Multi-signatory public comment response

Re: Project File #608020 Cape Cod Bridges Project

However, the current design for the multi-modal facility on the Bourne South Quadrant presents significant safety and usage issues. Happily there is a straightforward opportunity for improvement: Replace the planned long, graded descent with a light-use overpass over the canal access road. As our public comment, we're highlighting the issues in more depth, and proposing a design modification.

Figure 2 - Location of proposed overpass versus existing path plan

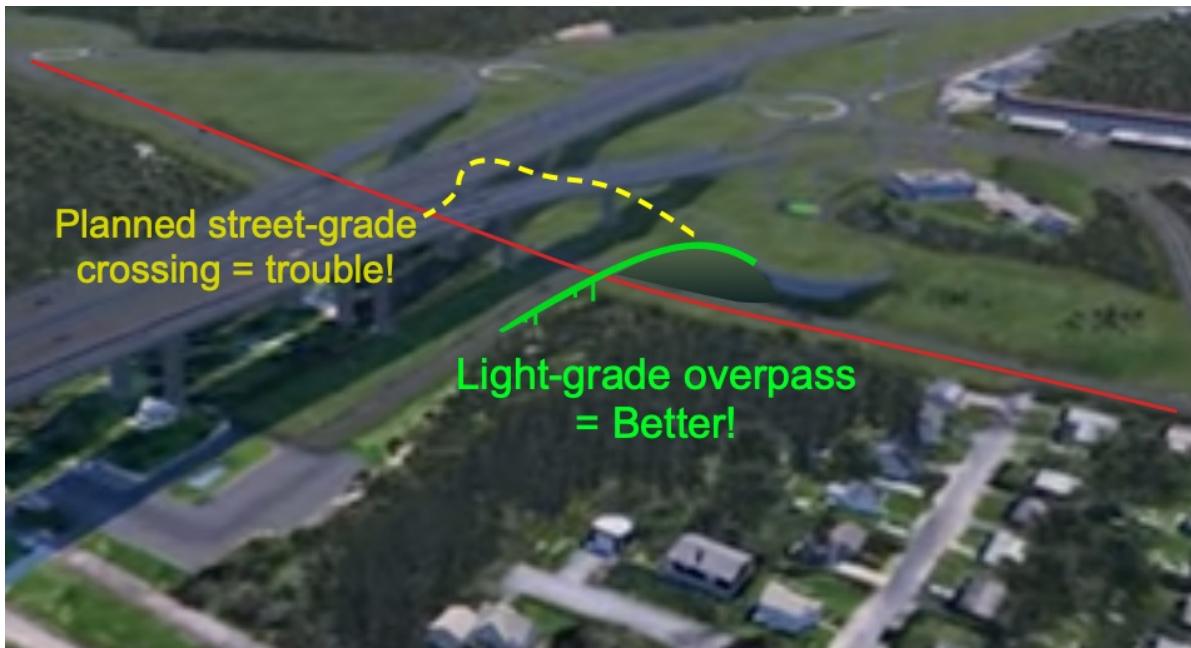
This design terminates the multimodal path with **an at-grade crossing of the Canal Service Road (Sandwich Road)** controlled only by a flashing beacon. See Figure 1.

This poses a variety of functional and safety problems. The at-grade crossing constitutes a high-risk hazard for multi-modal users, and represents a (potential) missed opportunity to provide for residents & visitors.

There is a simple, cost-effective alternative. Rather than constructing the path's long descent to road grade, the design could leverage the existing elevation and the now-planned retaining wall to create a light, ramped, grade-separated multimodal overpass, **eliminating the issue entirely**. Figure 2 illustrates this.

Figure 3 - Descent Ramp into existing public property

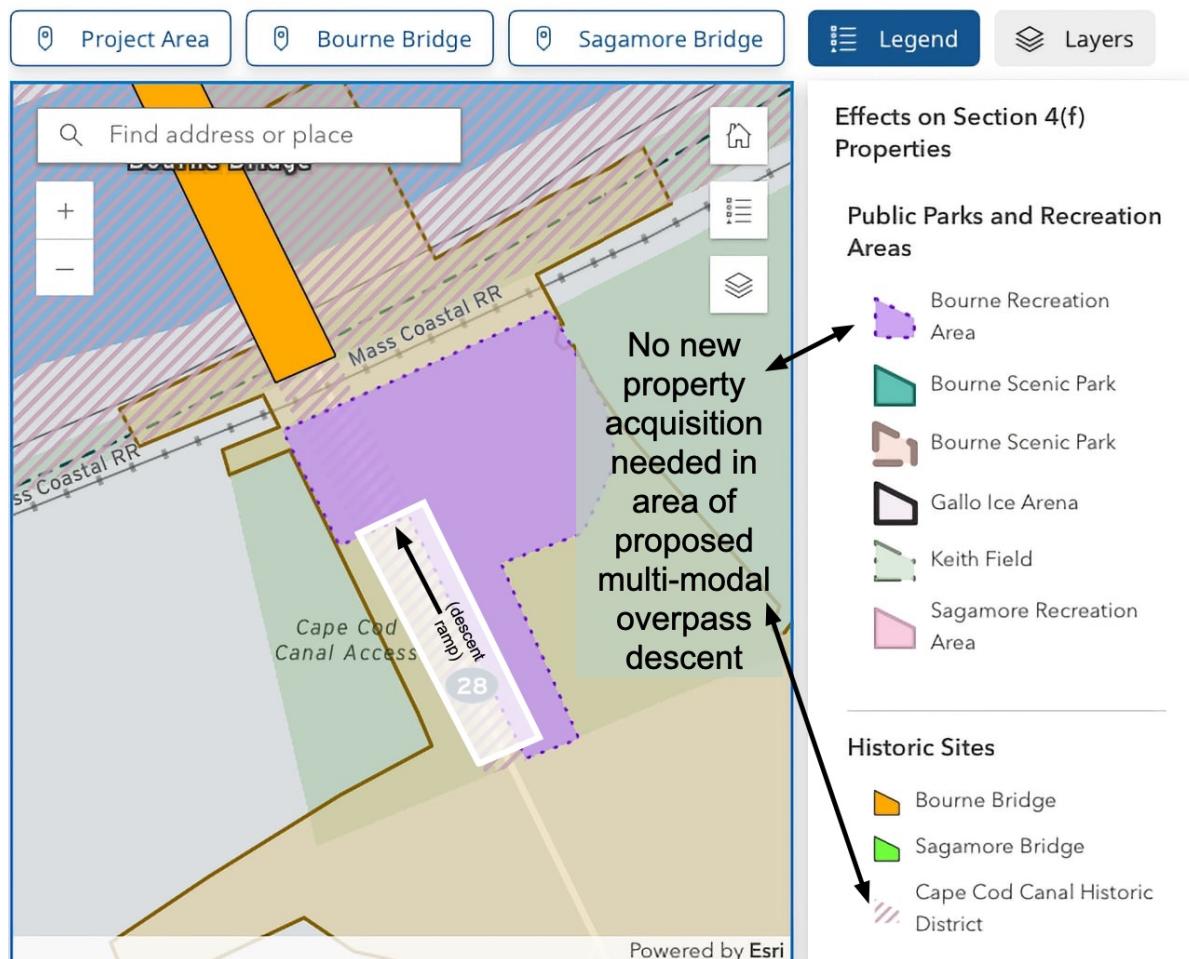
No new property required. The northern side of the overpass, which constitutes the descent over grade, can descend into the existing Bourne Recreation Area and adjoining Cape Cod Canal District property; no property taking is required. See rough placement illustrated in Figure 3.
